STAGE II CULTURAL HERITAGE IMPACT STATEMENT & CONSERVATION PLAN

145 Loretta Avenue & 951 Gladstone Avenue,
Ottawa, Ontario

Revision V5 October 2022

The current V5 (October 2022) PHASE II CHIS and Conservation Plan is submitted as part of a site plan control application and addresses comments provided by the City in a formal pre-application consultation and review by the OUDRP. The Stage Two document addresses the approach to the conservation of the building elements, the impact, how work will be done and protection of the building during the construction phase.

Figure 18: Standard Bread Building Ground Floor Plan illustrating the layout of the link with the mushroom columns establishing the floor grid. Source: Hobin Architecture 2022.

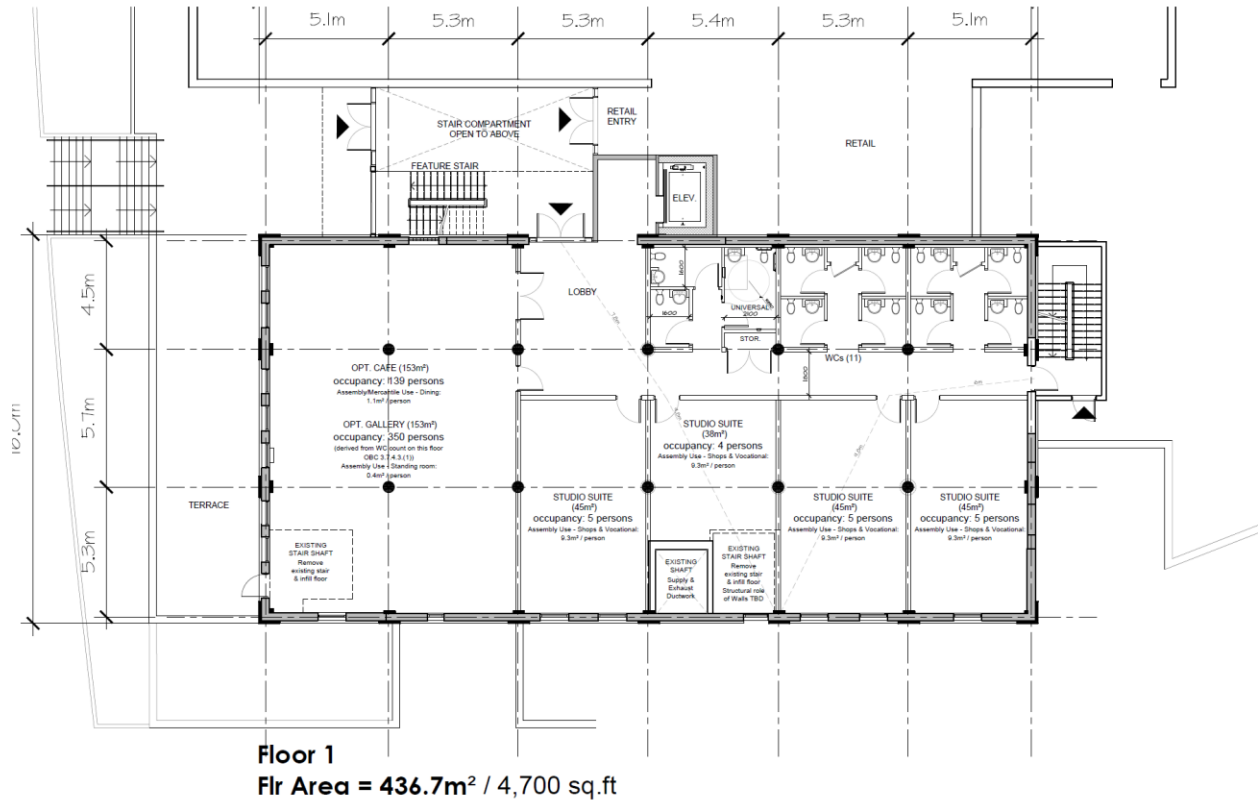
- The treatment of the west façade and how the glass link will be attached to the heritage building. **Needs further design development. The link between the podium and Standard Bread Building has been reduced to three storeys and the north elevation of the link has been setback further**

Heritage Staff identified the treatment of the west façade and how the glass link will be attached to the heritage building needing further design development.

The link between the podium and Standard Bread Building and the north elevation of the link has been setback further to provide a more three-dimensional view of the building when seen from the west. The ground floor expression of the masonry podium at the bay next to the link has been replaced with a more industrial looking metal treatment. The cornice detail of the Standard Bread is a distinct feature that has been picked up as an awning detail over the entrance of the link and as a feature of the ground floor of the awning/podium.

Figure 33: The 1930 view of the front entrance with a stairway leading from Gladstone and an entrance on the right-hand side of the building are defining features.

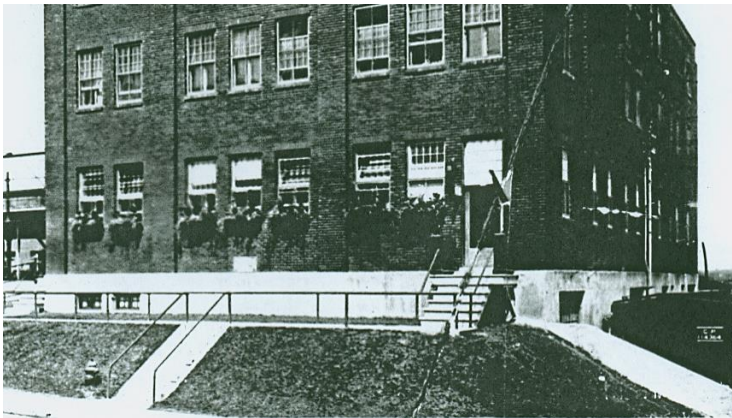
- Staff questions about the following aspects of the proposal, have been addressed as follows:
 - The treatment of the entry/entrance to the designated building as well as any sign board being proposed. **The existing entrance will be maintained as a functional door. The sign board treatment needs further design development as there was no signboard on the building when completed in 1924;** (see the conservation Plan Chapter 7 of this report)

The design of the landscaping / streetscape in front of the Standard Bread building on Gladstone Street and its interface with the building has been developed based on historic photographs that document the location of the main entrance to the building as a character-defining feature. The historic entrance is interpreted from the street with stairs leading to the linked entrance from the public sidewalk.

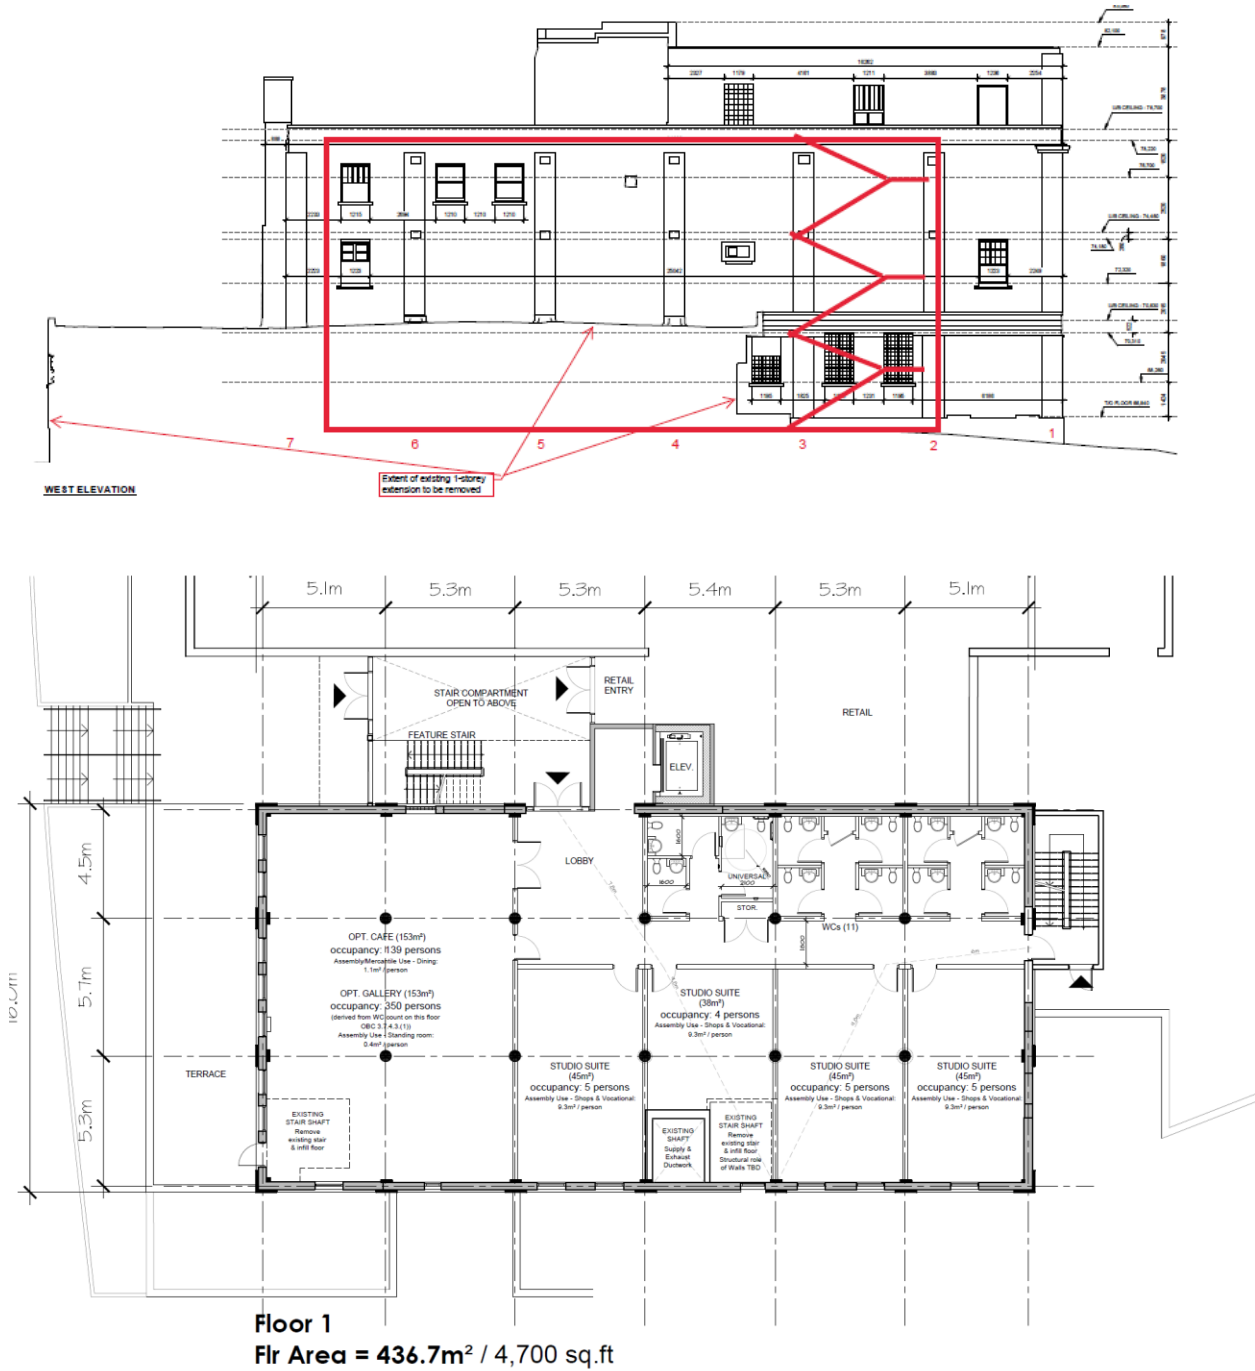
- 9.7 The reduction of height of the glazed link is positive, but could the projection be moved away from the heritage building?

Response: *The stair & elevator projection above the roof of the glazed link is set back from the front edge of the link, which itself is set back from the front face of the Standard Bread Building. The front of this projection is sloped, to diminish its scale and visibility. It is positioned against the west side wall of the Standard Bread Building as this is where the proposed new main stair and elevator for the building will be. The setback and form of this projection are designed to minimize visible impact on the Standard Bread Building.*

The link between the podium and Standard Bread Building and the north elevation of the link has been setback further to provide a more three-dimensional view of the building when seen from the west. The ground floor expression of the masonry podium at the bay next to the link has been replaced with a more industrial looking metal treatment. The cornice detail of the Standard Bread is a distinct feature that has been picked up as an awning detail over the entrance of the link and as a feature of the ground floor of the podium.

1. The link (shown in red) will be set back from the front corner of Standard Bread by approximately 5m with its front wall aligned with the second pier. The height will be lower than the factory parapet except for the rooftop access projection shown in the renderings. The exposed brick on the west elevation will be retained as part of the conservation plan.

2. On the west elevation the new stair will be positioned between the 2nd and 3rd column/pier. Between the third and fourth piers openings will be made to provide access from the link into the Standard Bread Building on each level with the feature stairs providing access to the roof.
